Presentation to the Commission

Summer Units 2 and 3 COL Application Review Safety Evaluation Report Panel 1

October 12, 2011

Affected Systems

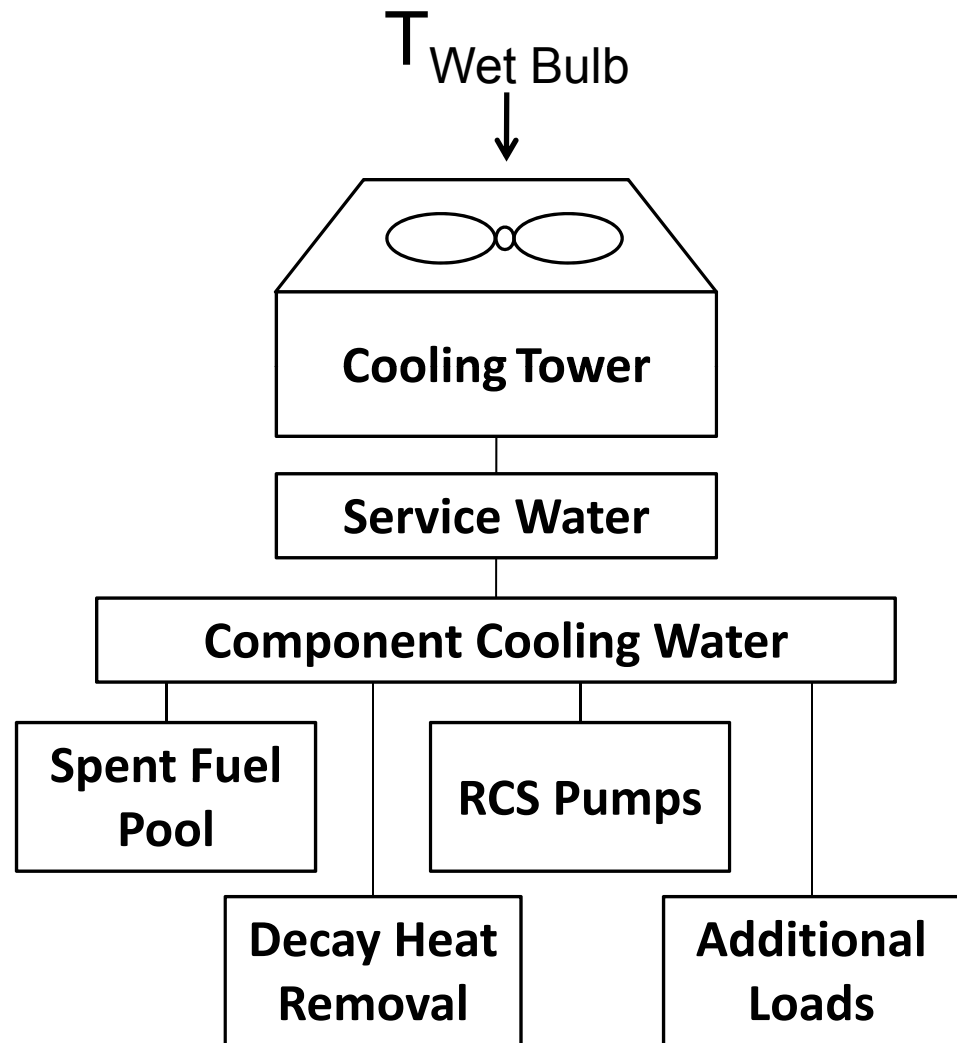
- Passive Containment Cooling System
- Service Water System
- Nuclear Island Non-radioactive Ventilation System

Section 2.1, “Geography and Demography”

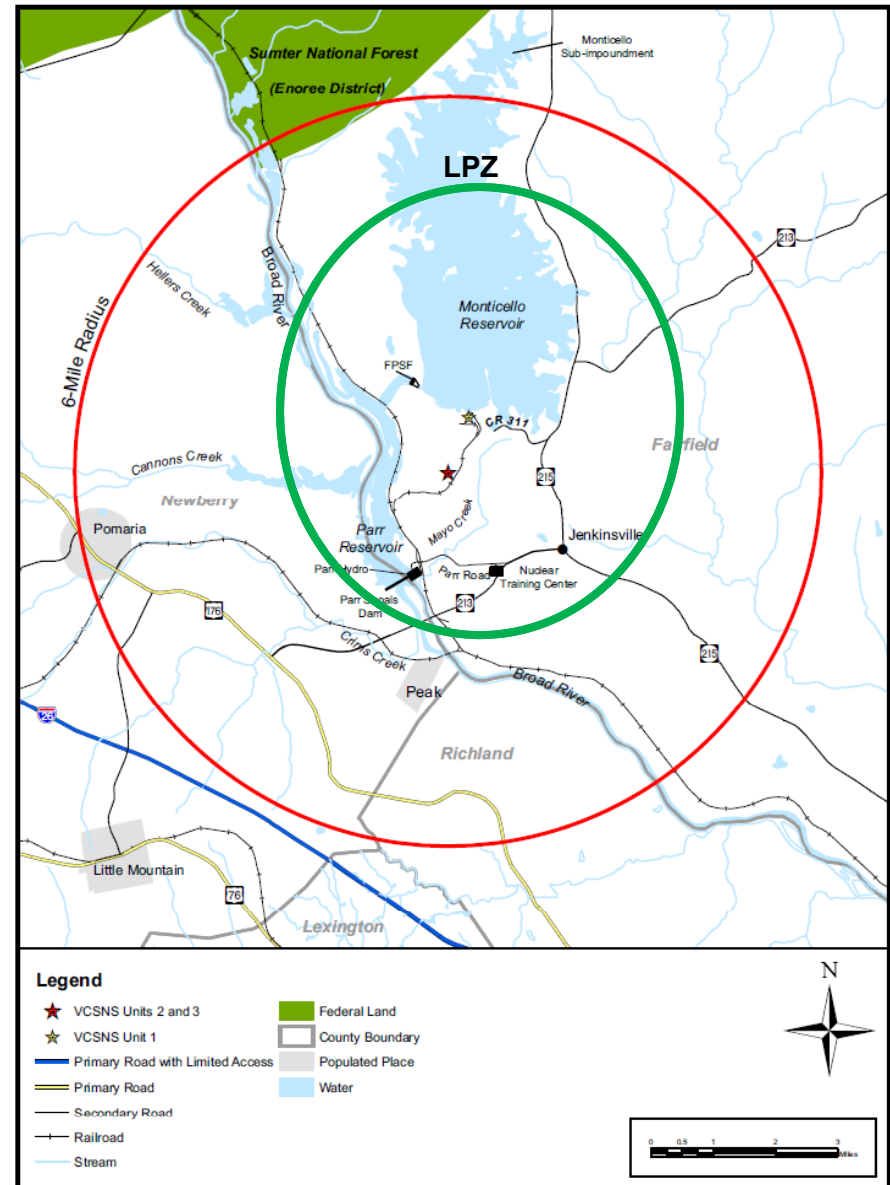
- VCSNS Units 2 and 3 to be co-located approximately 1 mile south of existing VCSNS Unit 1 site in rural Fairfield County, South Carolina
- The LPZ is within a 3-mile radius circle of Unit 1

Section 2.1, “Geography and Demography”

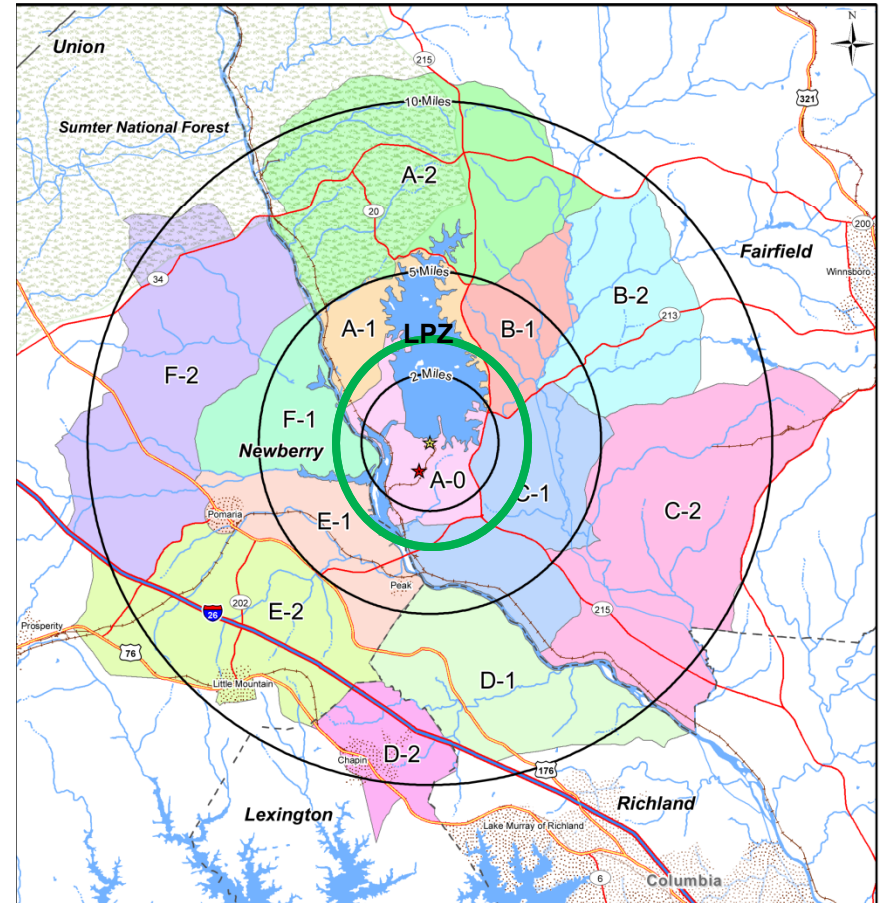
- Largest nearby population center is Columbia, SC, about 14 miles southeast.
- Appropriate protective measures can be taken in the event of an accident for individuals in the low population zone.
- The distance to the nearest boundary of the closest population center containing 25,000 or more residents meets NRC requirements
- The population density around the site does not exceed NRC guidelines
